DOCUMENT 00 9113 – ADDENDUM #5

- A. Project Name: **Sandoval County Sheriff & Emergency Operation Center**
- B. Owner Project Number: **FY22-SCPW-05**
- C. Owner: **Sandoval County**
- D. Architect: **RMKM Architecture, P.C.**
- E. RMKM Architect Project Number: **1904**
- F. Date of Addendum: **23 February 2022**

EXTERIOR STAIR

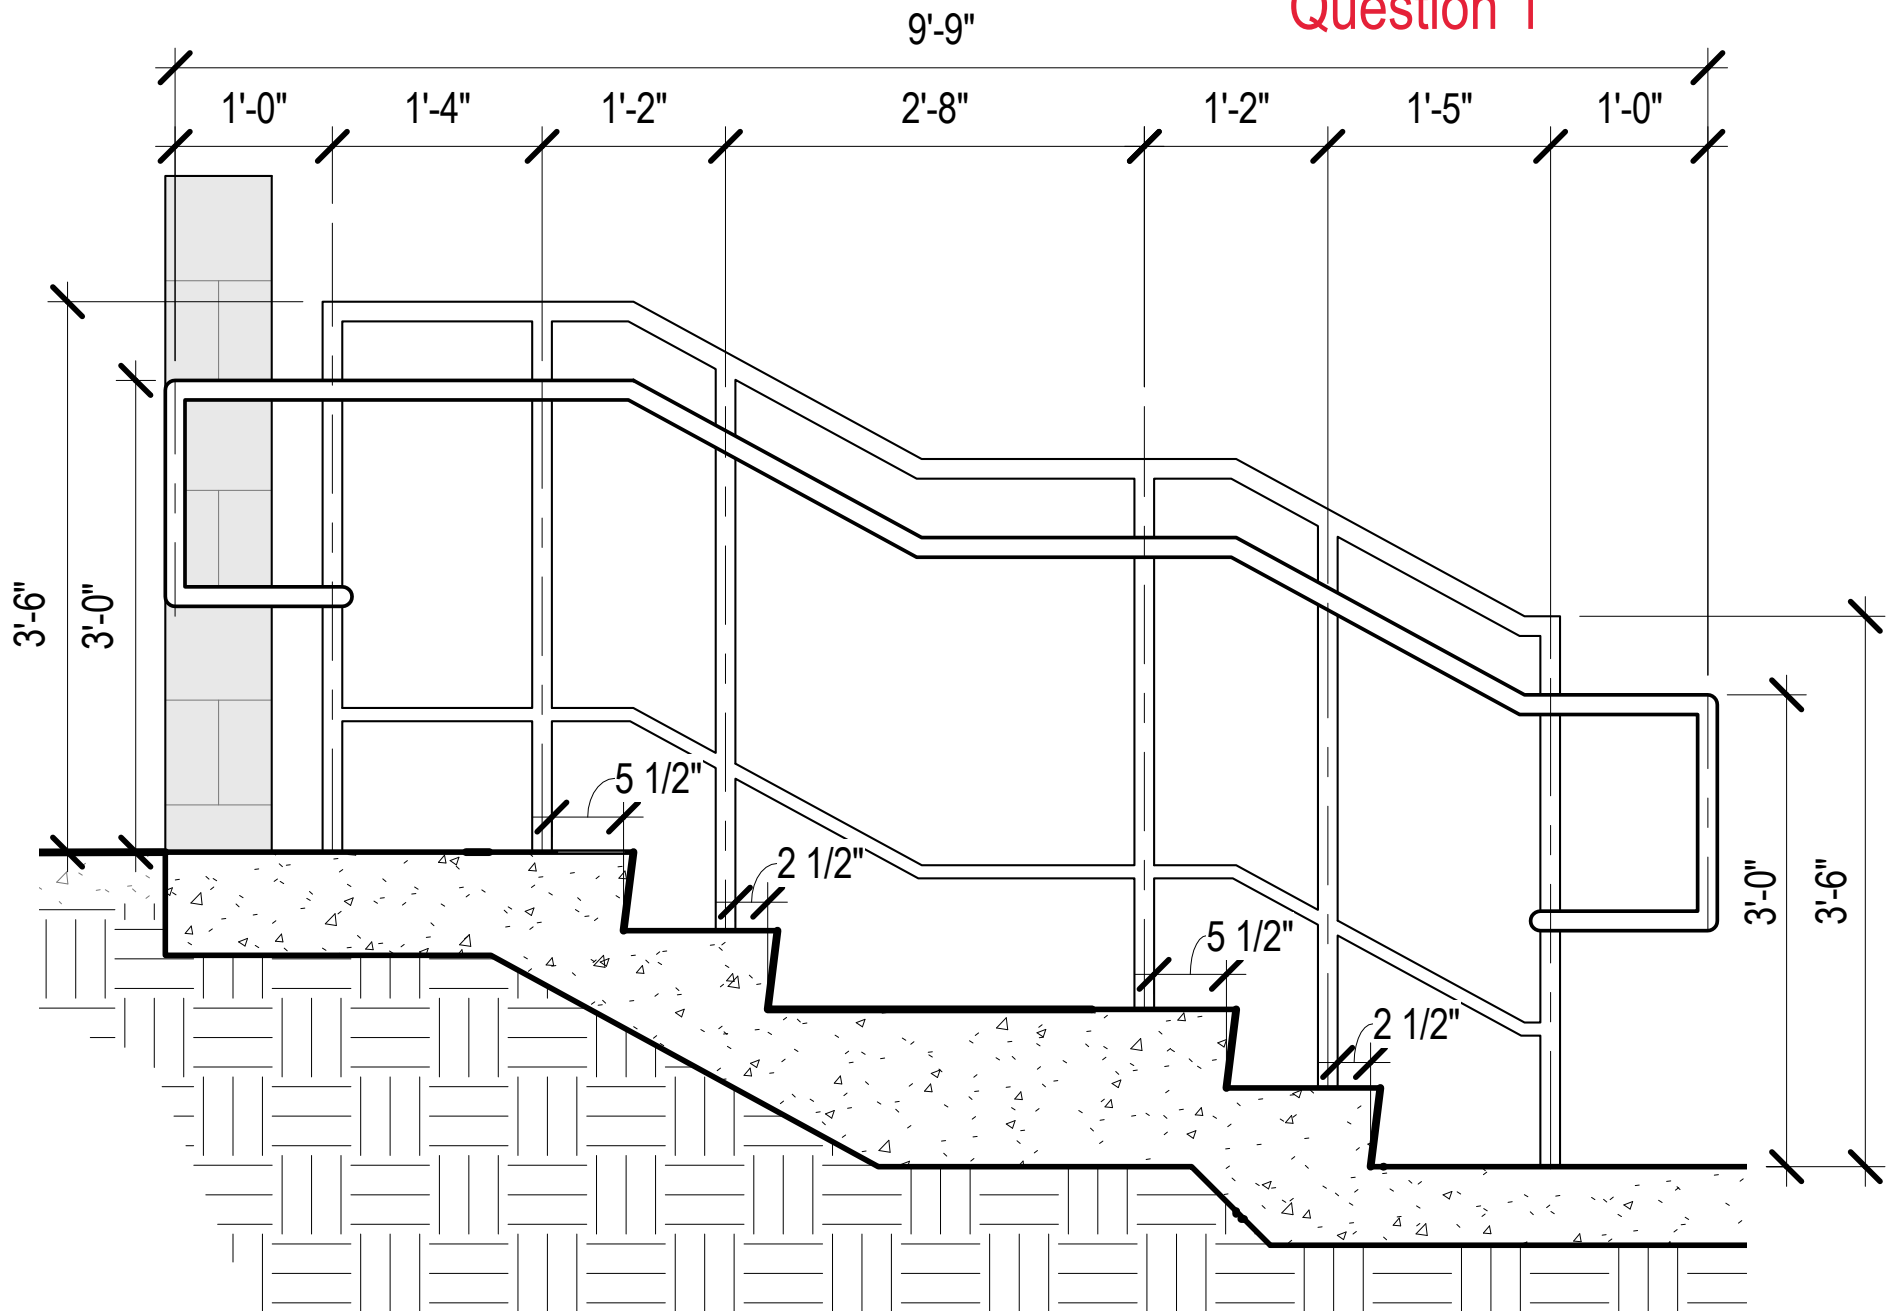
1. Please provide a detail for the exterior stair rail noted 05 5213A on sheet AS101. **Please see attached section of the south exterior stair showing the updated stair dimensions and guard / handrail dimensions.**
2. Please confirm that the Landscape Allowance of \$75,000.00 is the only cost to be included for landscaping on this project. **This was answered in Addendum 3.**
3. The fencing as specified in 32 3119 does not appear to match the existing fencing at the Courthouse. Please confirm this fencing specification. **This site fencing listed in Spec Section 32 3119 is described in Part 2.2 and is manufactured by Deacero S.A. DE C.V. and is called the Classis Fence Panel and Post** and can be located at website: <https://www.deacero.com/classic-fence-panel-and-post>. It is shown to be placed on the west and north site boundaries and will match the following photographs:
